**US Army Corps
of Engineers**
Philadelphia District
Wanamaker Building
100 Penn Square East
Philadelphia, PA 19107-3390
ATTN: CENAP-OP-R

Public Notice

Public Notice No. **CENAP-OP-R-2008-0777** Date **FEB 26 2015**

PROPOSED PERMIT MODIFICATION: In a letter dated December 3, 2014, Fishermen's Energy, LLC requested that this office modify the above referenced Department of the Army permit. The following changes have been requested:

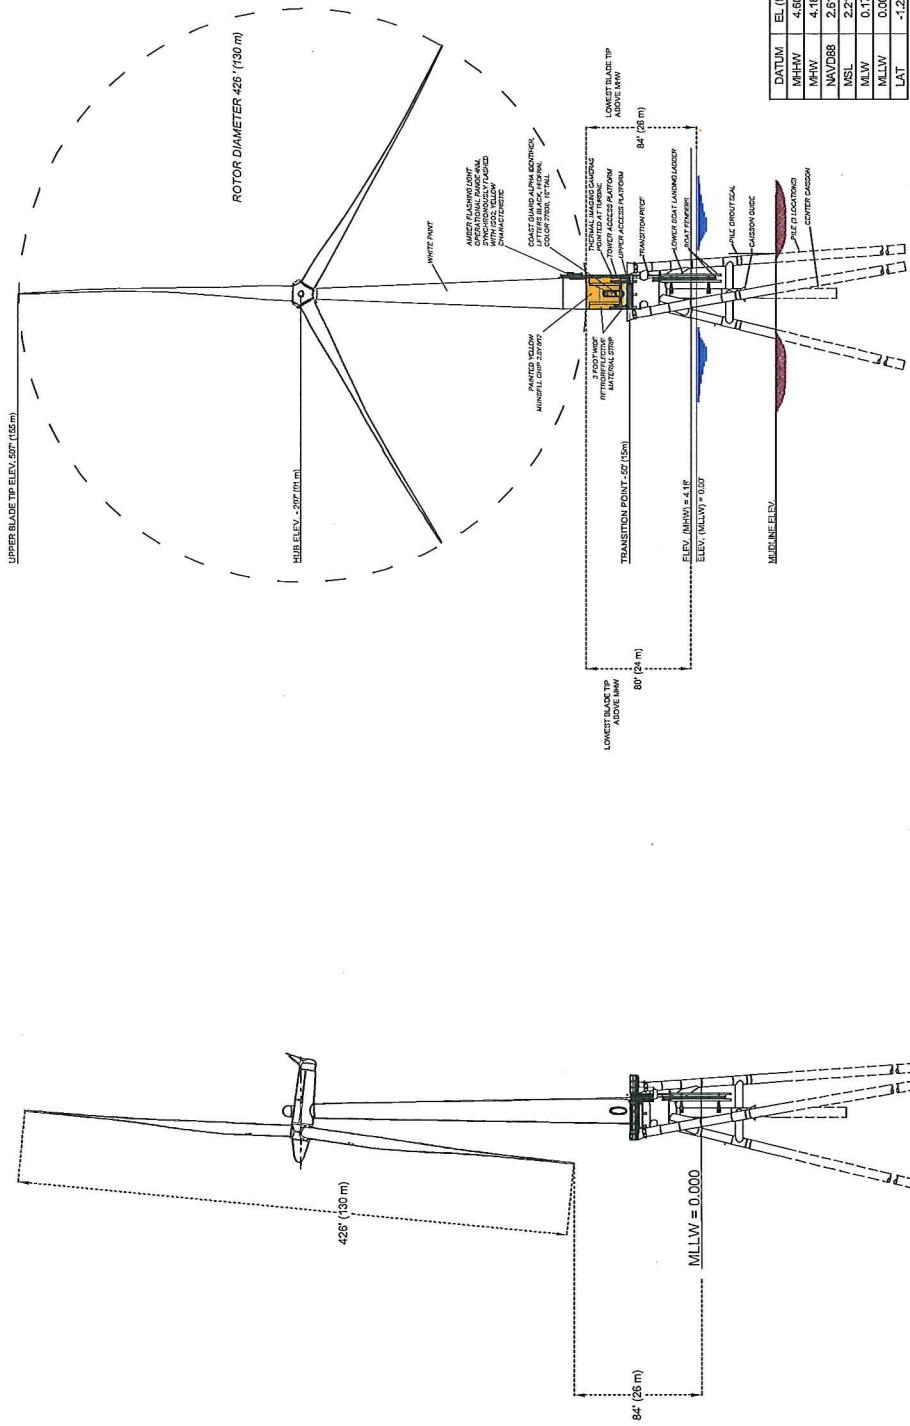
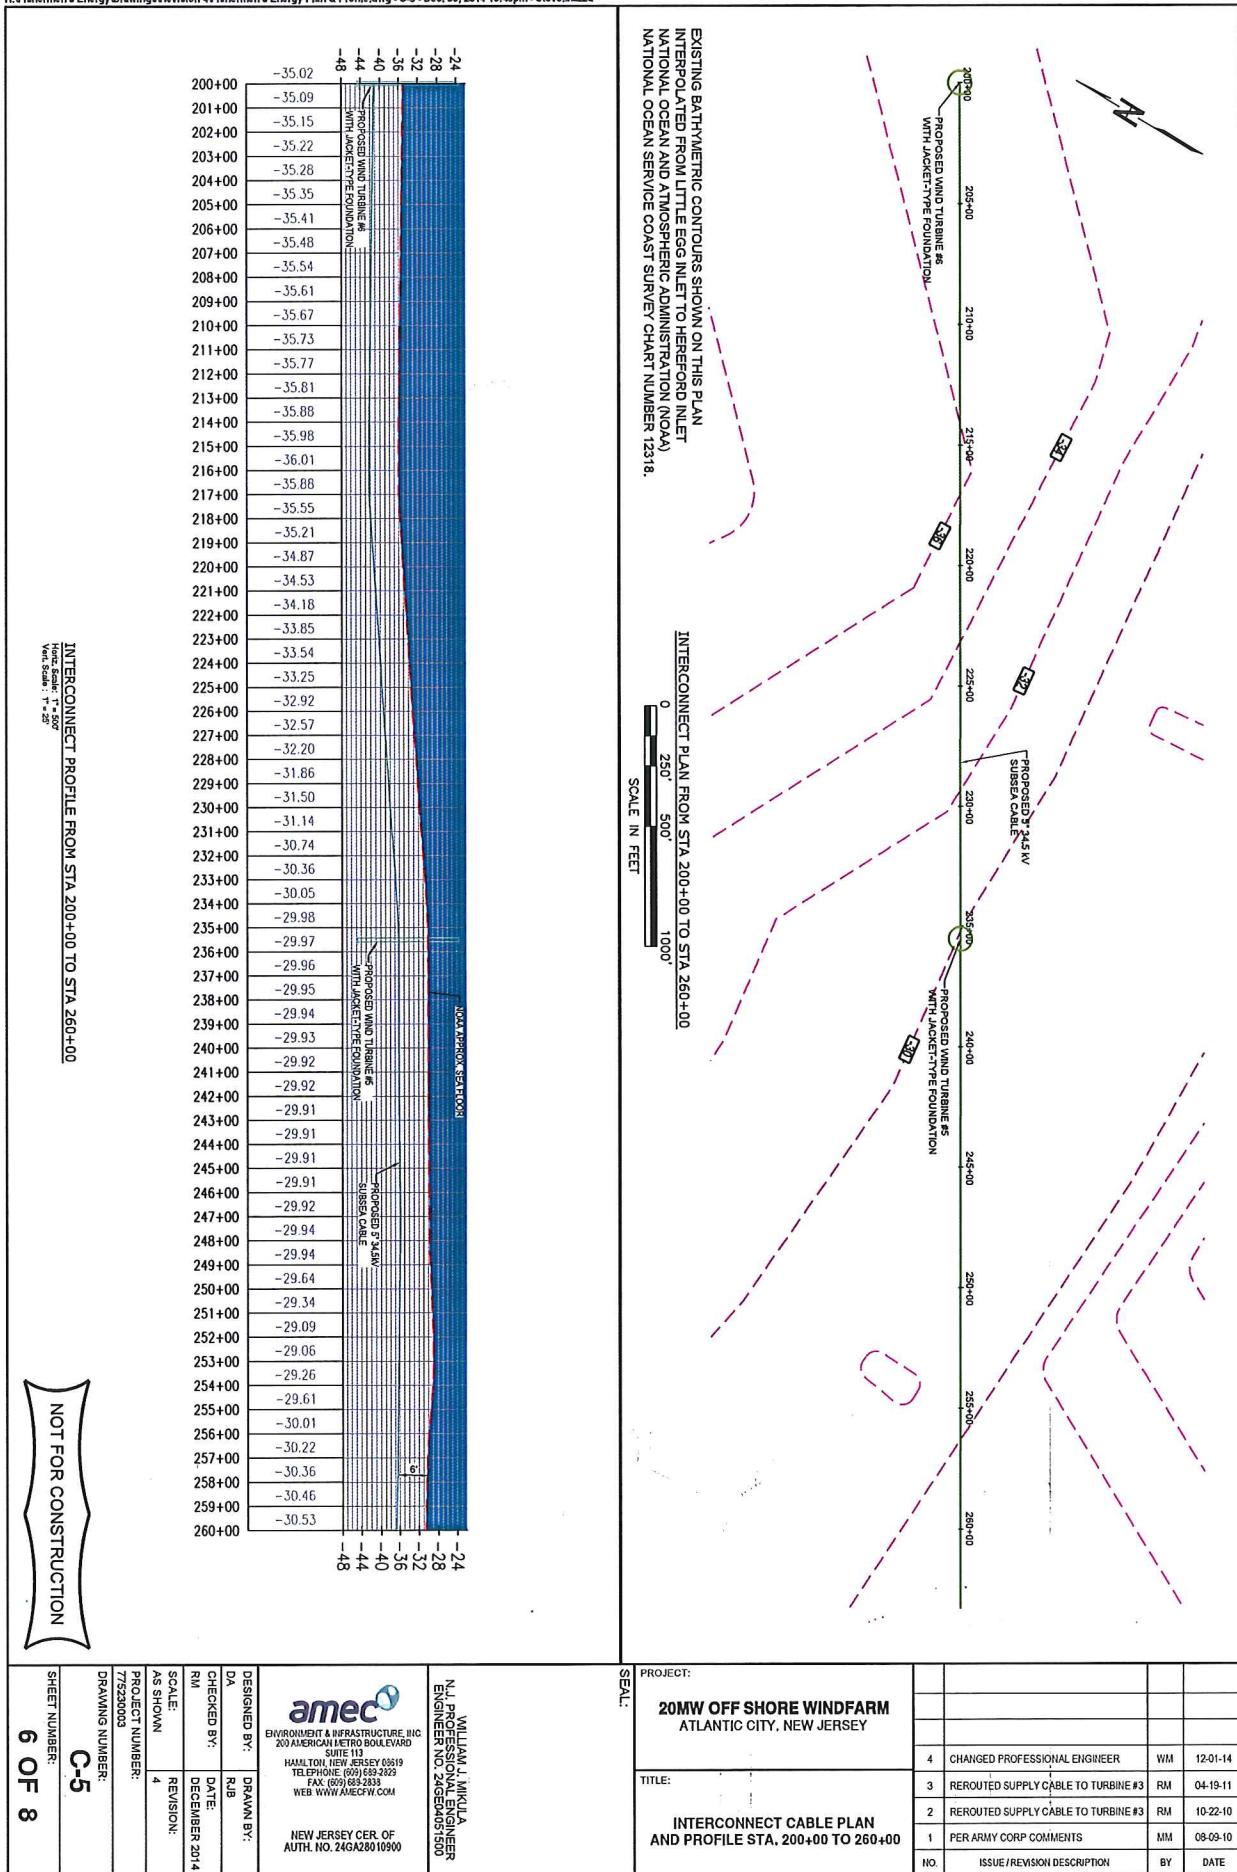
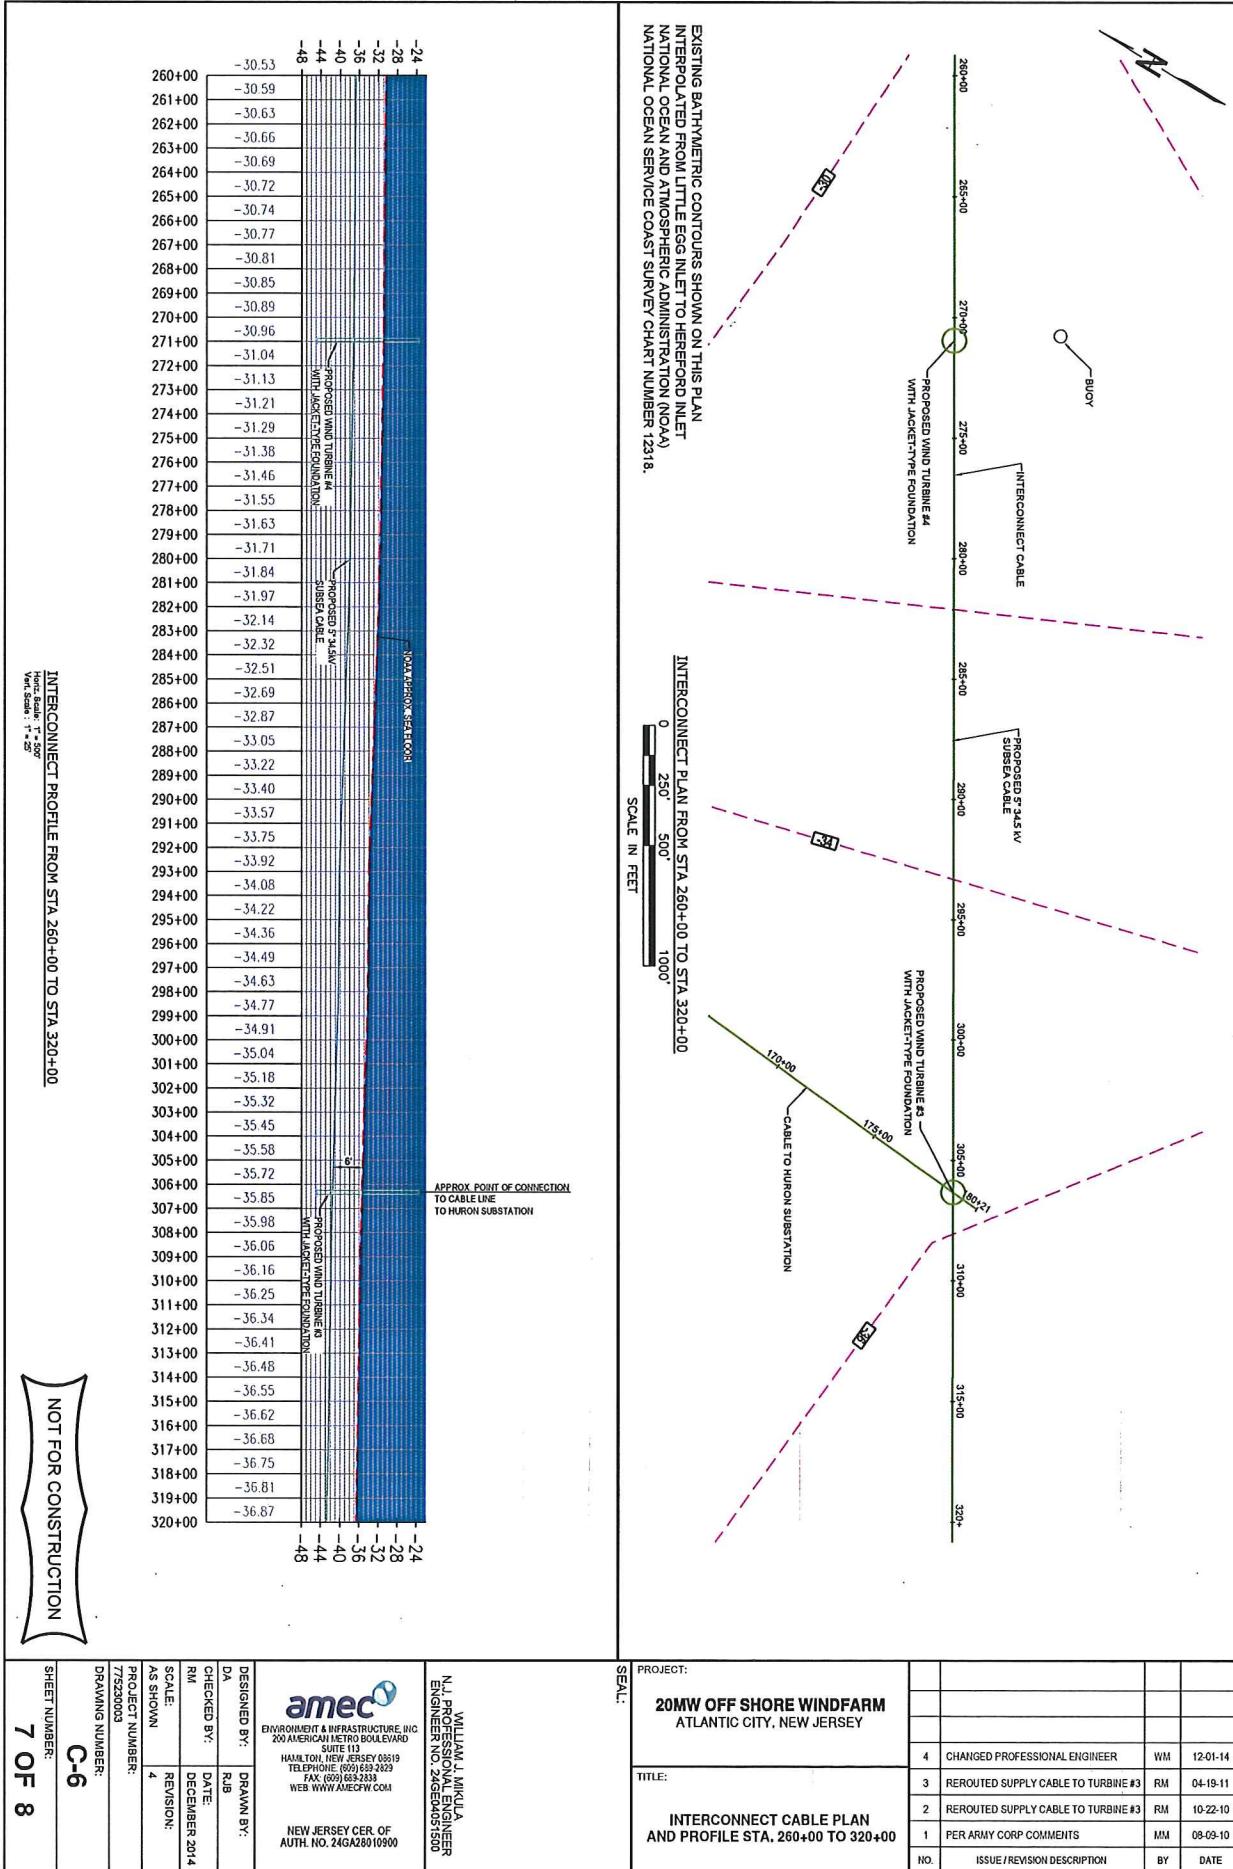
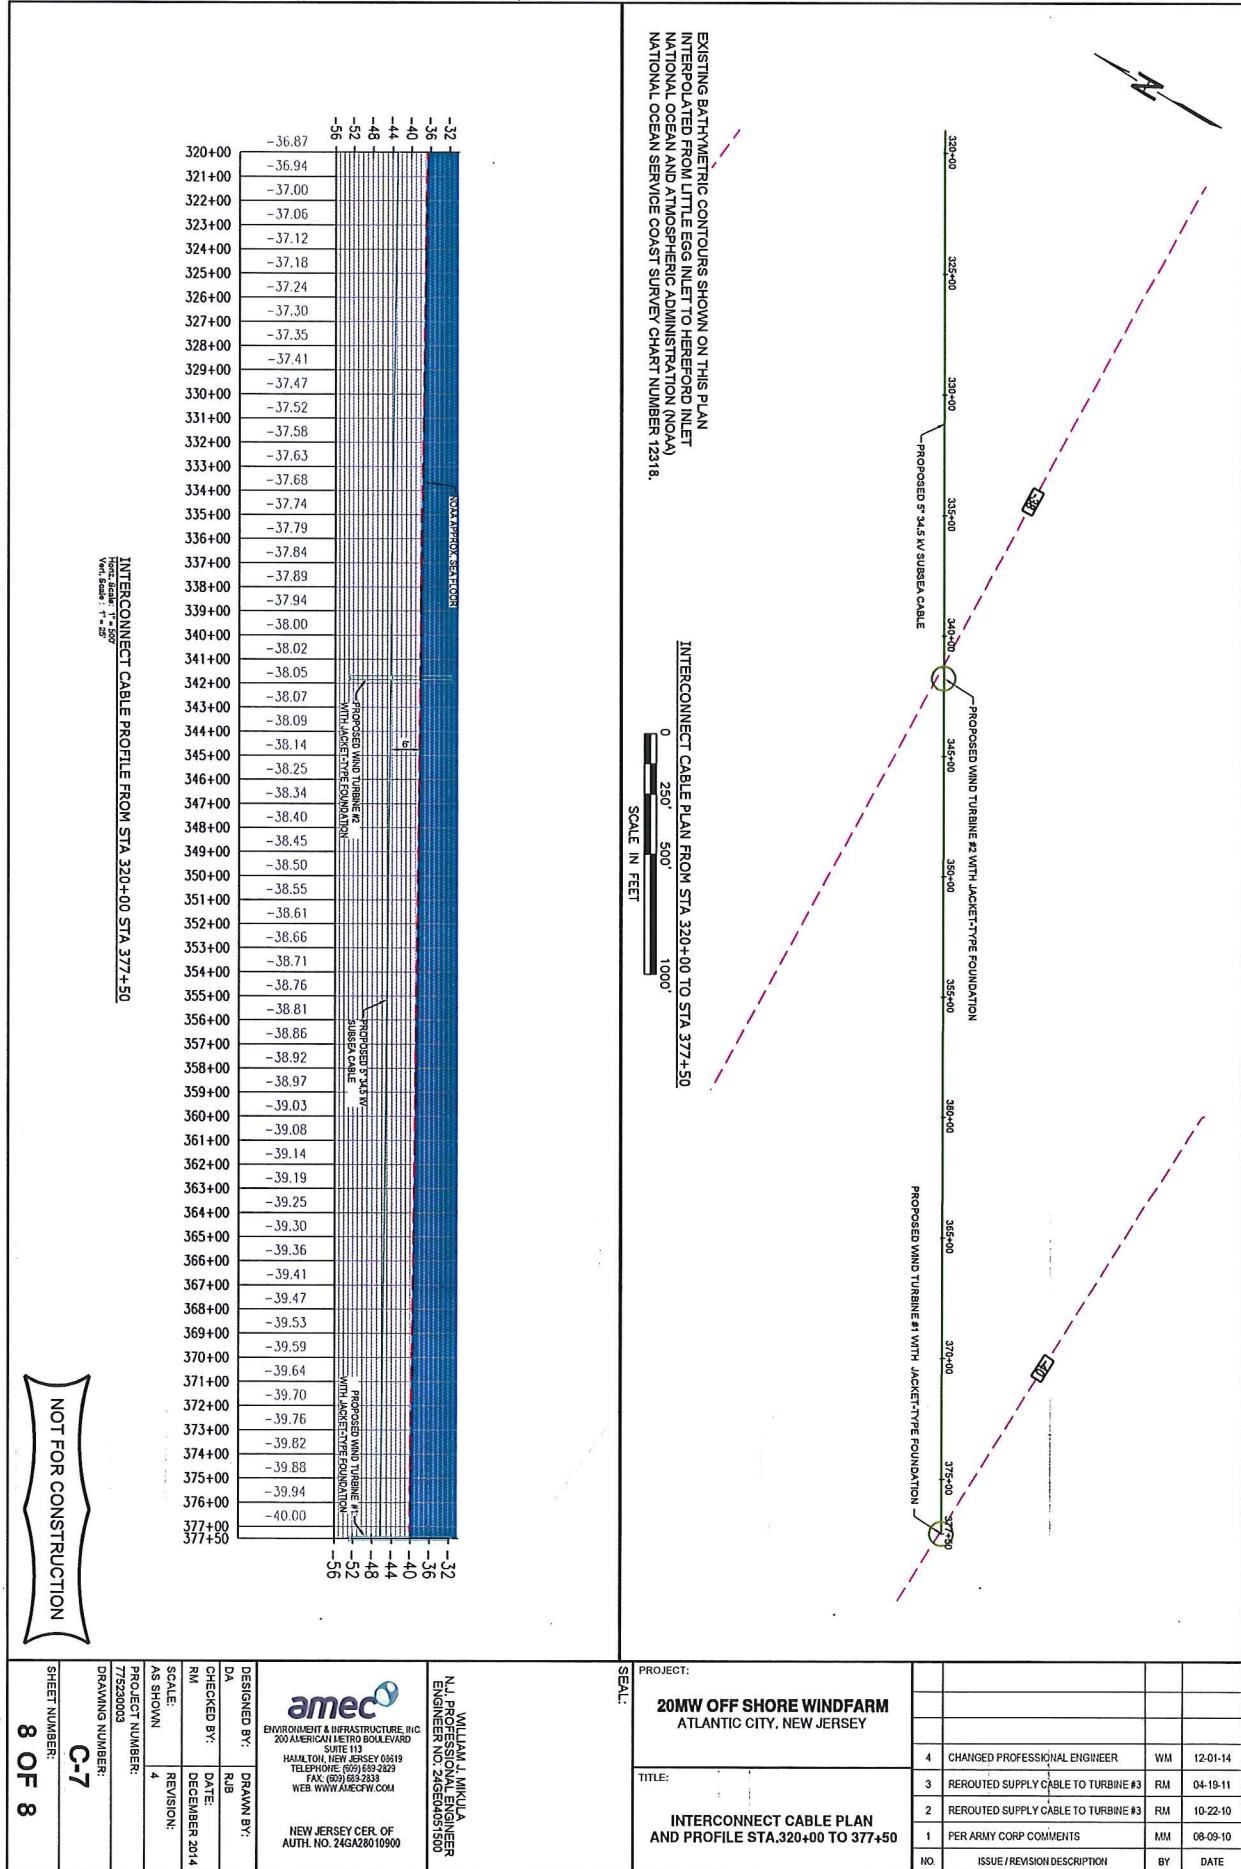
The permittee would install six (6) 4 megawatt turbines, with a maximum output of approximately twenty five (25) megawatts. Each of the three (3) turbine blades would be two hundred thirteen (213) feet long, as opposed to the previously approved one hundred ninety two (192) foot long blade. The turbine hub height would be up to two hundred ninety seven (297) feet above mean high water, as opposed to three hundred (300) feet above mean high water. The lowest the turbine blades would be during rotation is eighty (80) feet above mean high water as opposed to one hundred (100) feet, and the highest the turbine blade would be during rotation would be five hundred seven (507) feet above mean high water as opposed to five hundred (500) feet.

The jacket foundations would be changed, requiring the installation of four (4) eighty four (84) inch piles that would be driven through ninety (90) inch sleeves used to support the turbine. The issued permit authorized a monopole installation and was modified to allow for the installation of a total of eighteen (18) forty eight (48) inch diameter piles. The piling sleeves are incorporated into the base of the turbine structure. The work would be performed using either a jack-up barge or a floating crane barge. The maximum sound generation for each pile would be approximately 199 dB (re 1 uPa) at the source, which as not charged from the previously approved permit. The structural braces for the towers would be seventy two (72) inches in diameter and would be located laterally along the foundation. Due to the redesign of the towers, there will be no need for the placement of filter or armor stone at the project sites. No discharge of dredged or fill material is now proposed for the installation of the individual wind turbines.
